## Development Permit Panel

Wednesday, April 14, 2021  
3:30 p.m.

1. **DEVELOPMENT PERMIT 17-792931**  
(REDMS No. 6612976)

PROPERTY LOCATION: 9700, 9720 and 9800 Williams Road

A2A

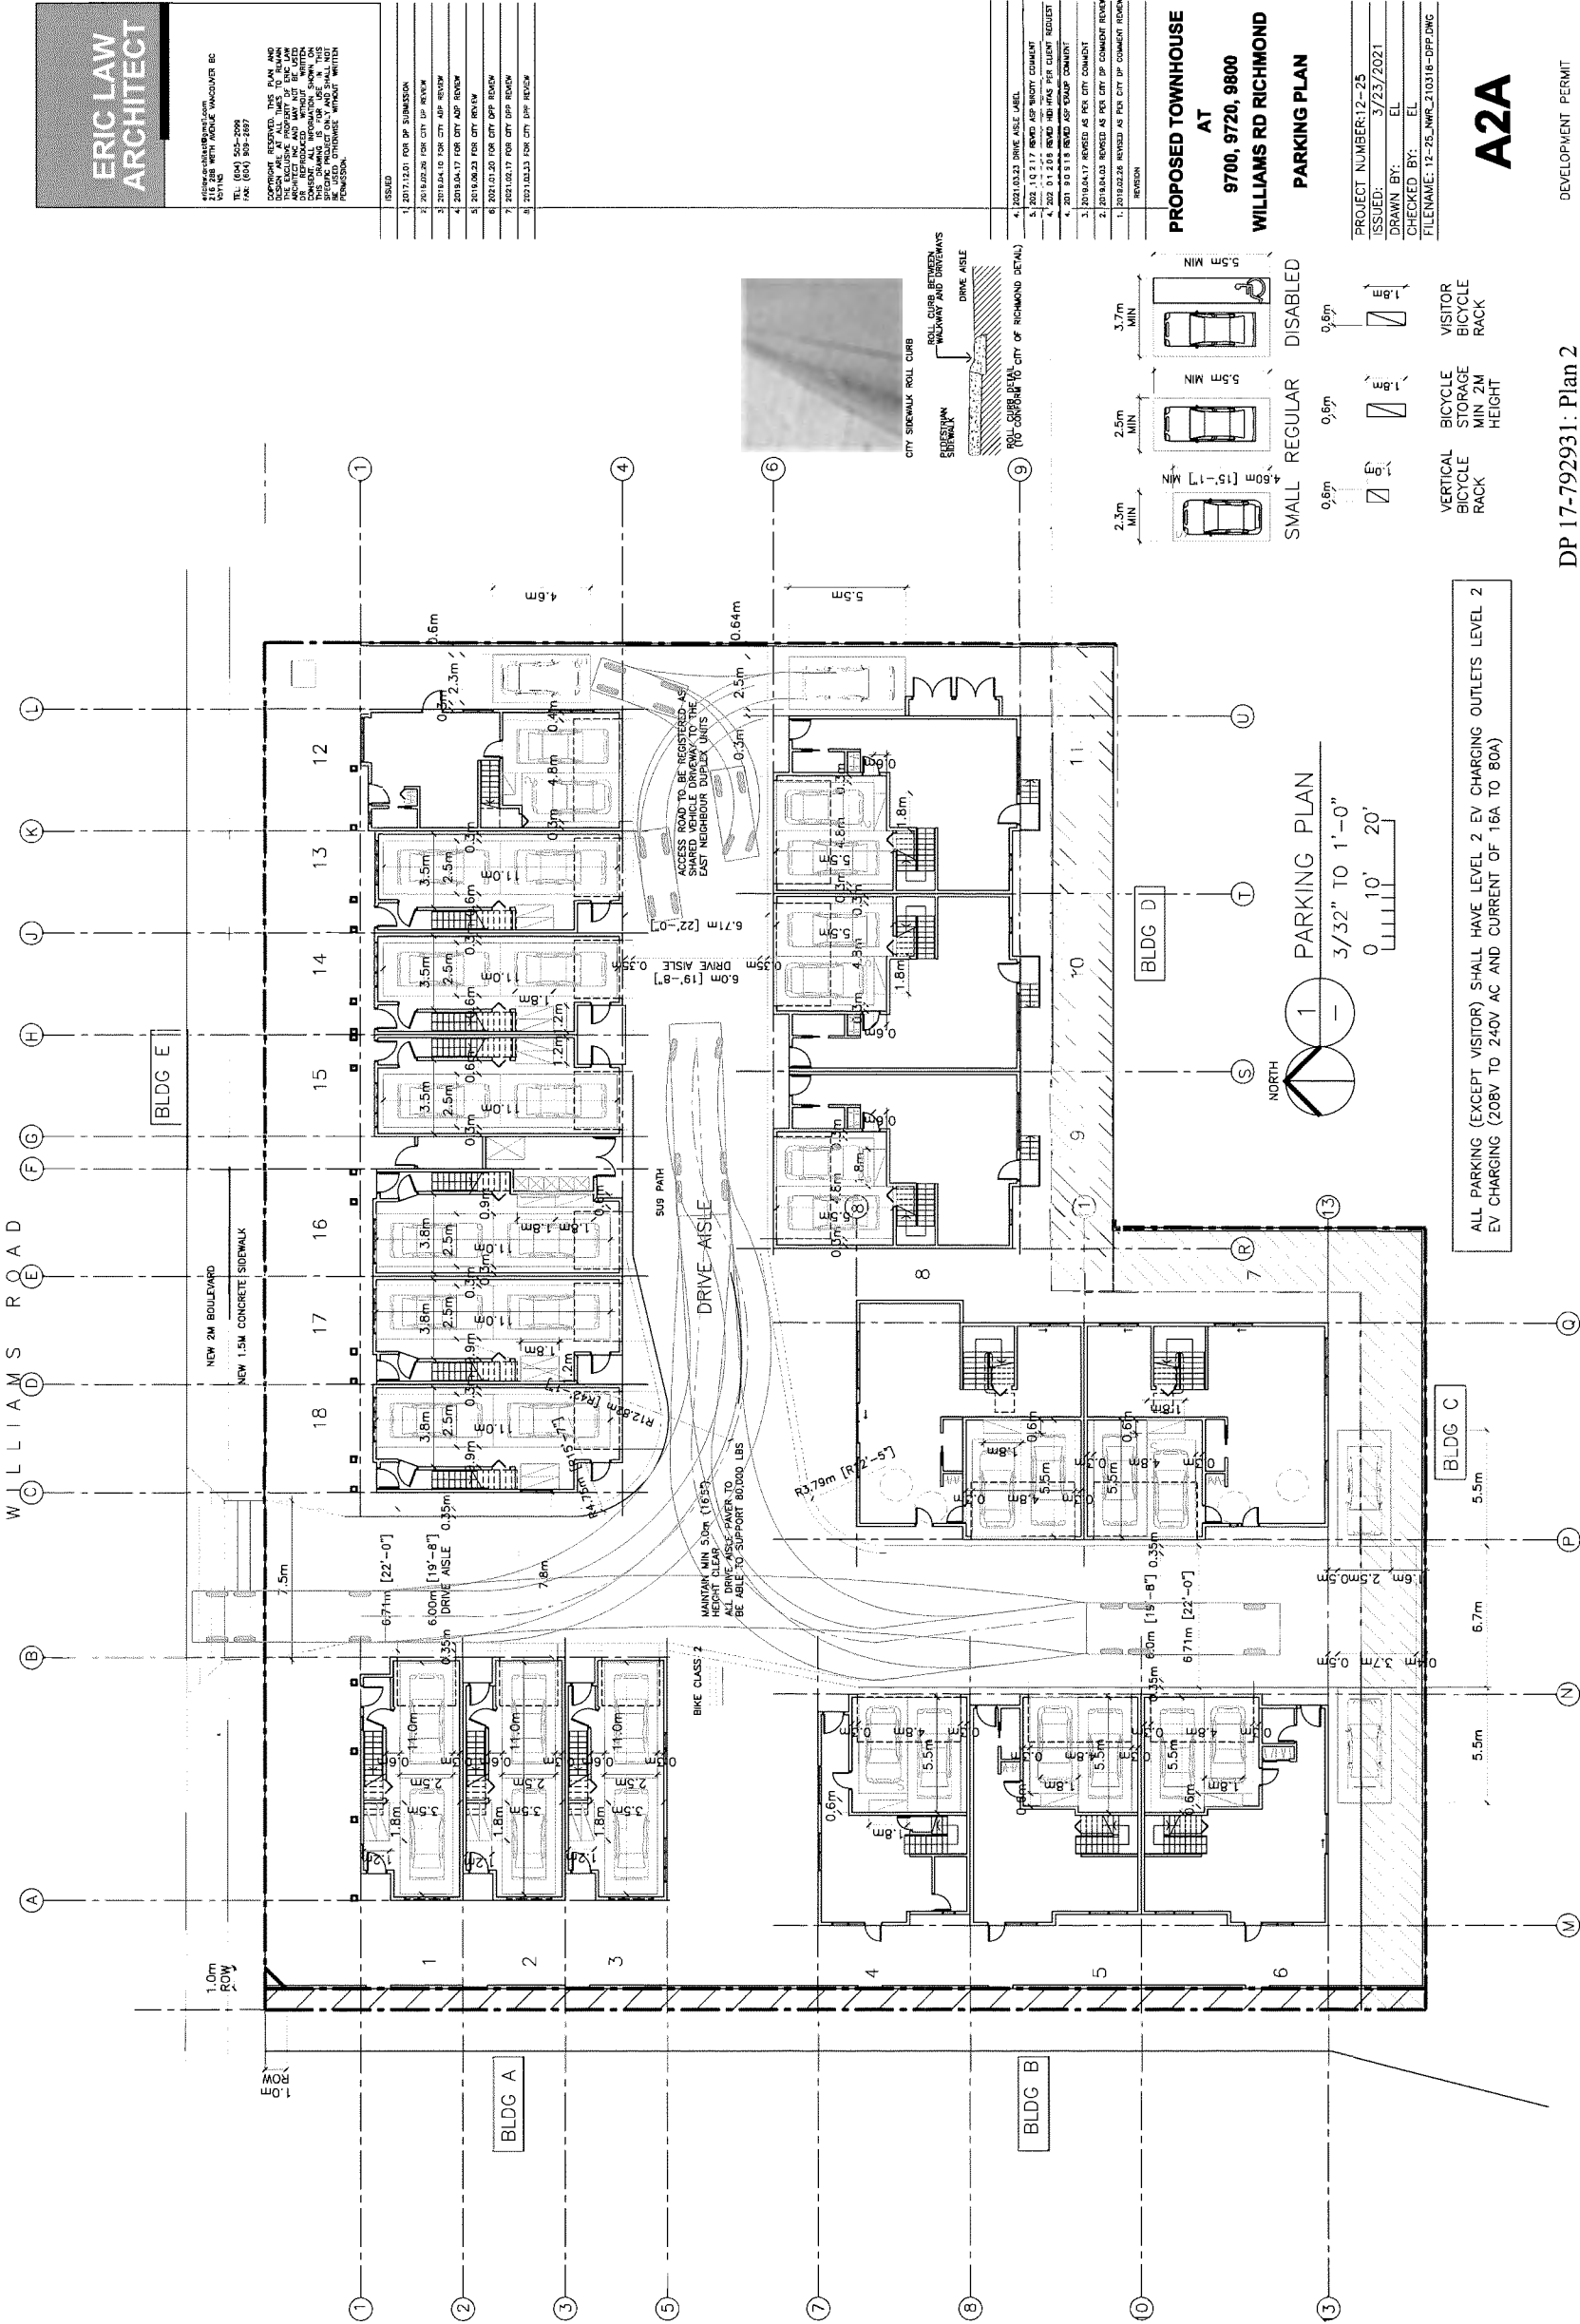
- ensure the accessibility of the rollover curb for users of mobility devices and carts;  
*The roll curb will conform to the City's standard and a profile and photo is indicated on [sheet] A2A.*
- appreciate the provision of two convertible units in the project;  
*Noted.*
- consider recessing the residential entry to Unit 7 (Type C2) and Unit 8 (Type C3) off the internal drive aisle to enhance the safety of residents and to be consistent with the design of other residential units;  
*The door to Unit 7 and 8 has been recessed.*
- consider removing the proposed planting immediately adjacent to the sliding door at the back of Units 7 and 8; also consider relocating the heat pump at the back of Unit 7 (Type C2) as it is located in front of the sliding door;  
*Planting has been adjusted to provide clear access to the sliding glass doors on units 7 and 8.*
